From: Joyce, Ryan M.
To: [Hall, Randy](#)
Cc: [Burns, Pamela Diane](#)
Subject: [External_Sender] Hatch alternative for plant service water leak
Date: Friday, May 18, 2018 7:23:23 AM
Attachments: [Scanned from a Xerox Multifunction Device.pdf](#)
[H11142 PSW Leak Location.pdf](#)
[BM11021 Sheet 9 Mark Up - Intake Structure Sump Pump Capacity.pdf](#)

WO SNC 245584
 Date: 05/14/18
 1P41 30 IN ELBOW
 INTAKE
 Sheet 1 of 1

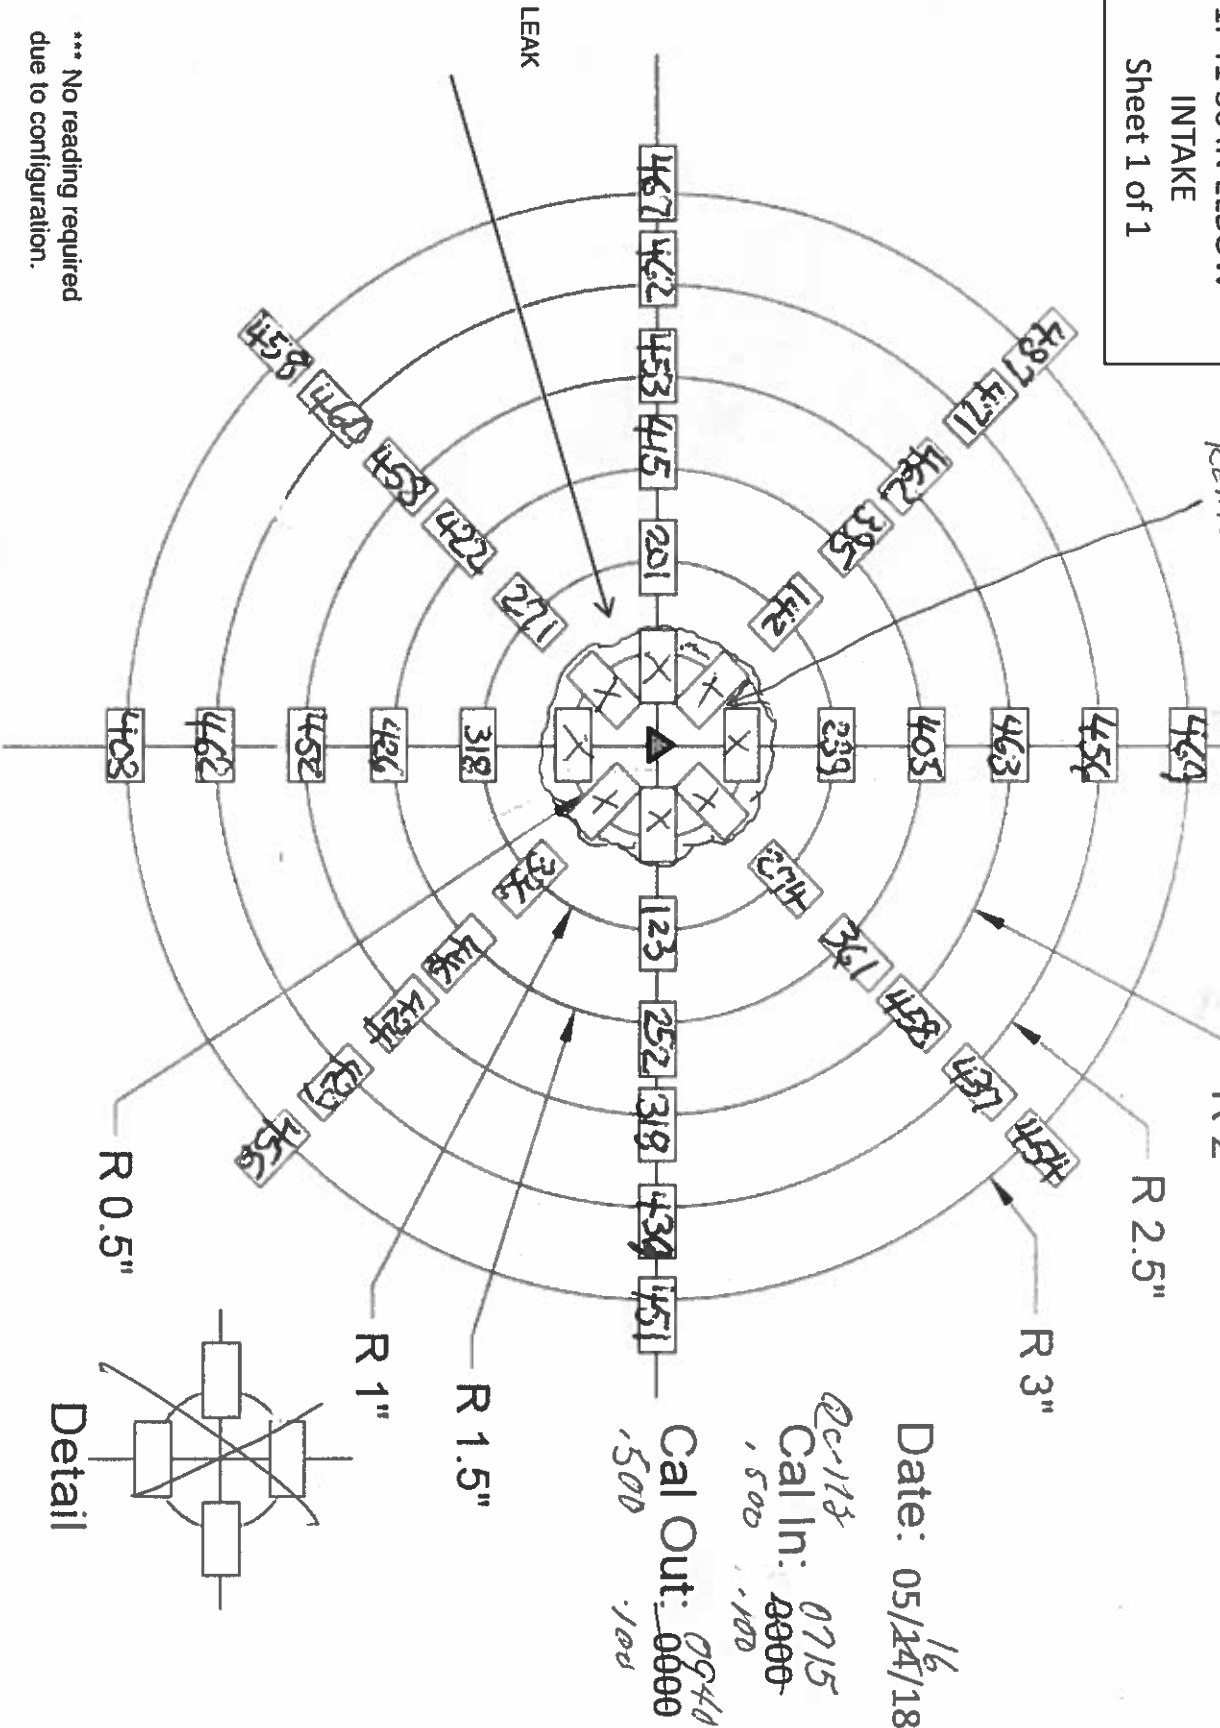
1. Provide a drawing showing the location of the leak with respect to the elbow. **Attached (H11142 mark up)**
2. Provide a thickness map showing the wall thickness in the vicinity of the leaking location. **Attached (scanned document)**
